Canterbury Bankstown City Council Submission to the State Significant Development Application SSD-97092958 – 2 and 2A Bullecourt Avenue, Milperra

Attachment A - Summary of Additional Information, Amendments and Recommended Conditions of Consent Requested by Council

Attachment B - Detailed Comments

Figure 3.6: Proposed Pedestrian Crossings within Internal Roads

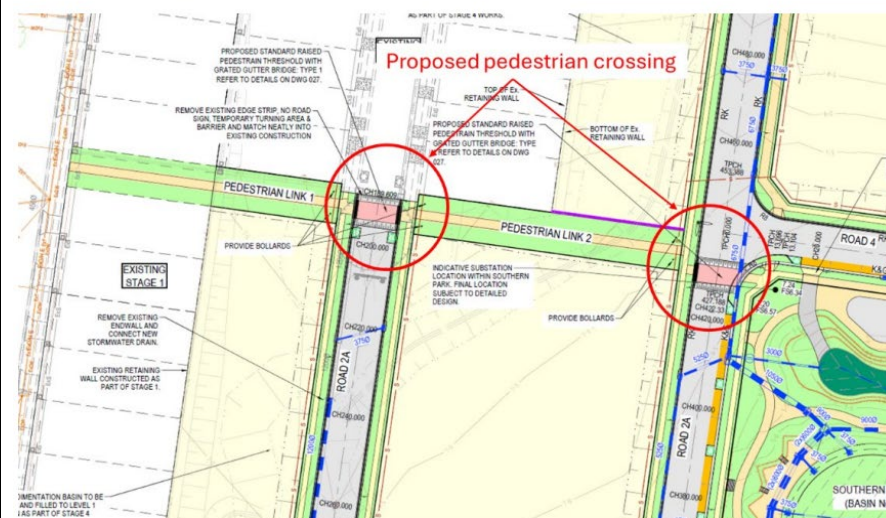
Furthermore, the Applicant proposes to install raised pedestrian crossings within the site boundary, as shown in Figure 3.6 of the report. If pedestrian activity is anticipated to be sufficient within the site to justify these internal crossings, it follows that pedestrians will also be interacting with Ashford Avenue.

In this context, the provision of a pedestrian crossing on Ashford Avenue is considered more appropriate and justified than crossings solely within the new roads within the development.

To comply with the condition C7 - Pedestrian crossings must be installed at least 5m away from stop/give way lines to allow one car space., the proposed pedestrian crossing on Road 2A must be proposed 5m to the south of the holding line on Road 2A. It is currently at the holding line and does not allow one car space to queue.

Figure 3.4: Proposed Site Access - Horsley Road

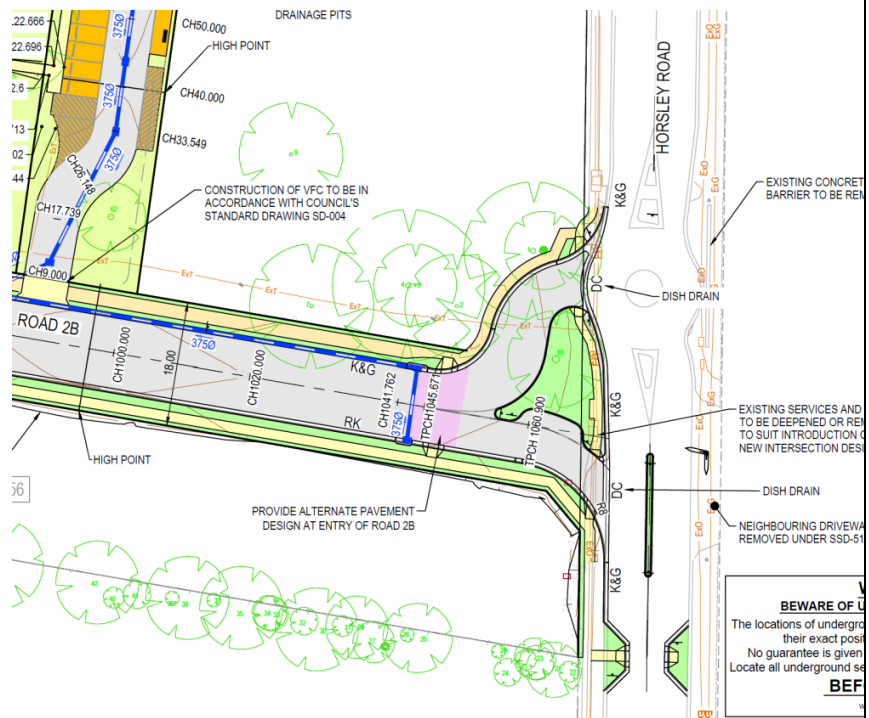
To reinforce the restriction on right-turn movements from Horsley Road into the access road, it is recommended that the gap between the existing roundabout splitter island and the proposed median island (located between the left-in access and the southern kerb extension) be filled. This treatment will physically deter and prevent illegal right-turn movements into the access road.

It is also recommended that the Applicant reconstruct the northern splitter island to bring the roundabout up to current standards with respect to pedestrian refuge width. The existing pedestrian gap measures approximately 1.68 metres, whereas current standards require a minimum width of 3.0 metres.

It is acknowledged that upgrading the southern splitter island to incorporate a pedestrian gap may inadvertently encourage motorists to utilise this gap to perform a prohibited right-turn movement from Horsley Road into the access road. Accordingly, it is acceptable for the Applicant to instead provide a raised pedestrian crossing, kerb extension, or slow point further south of the access driveway on Horsley Road, as shown in Figure 3.4, to improve pedestrian safety without compromising the proposed traffic restrictions.
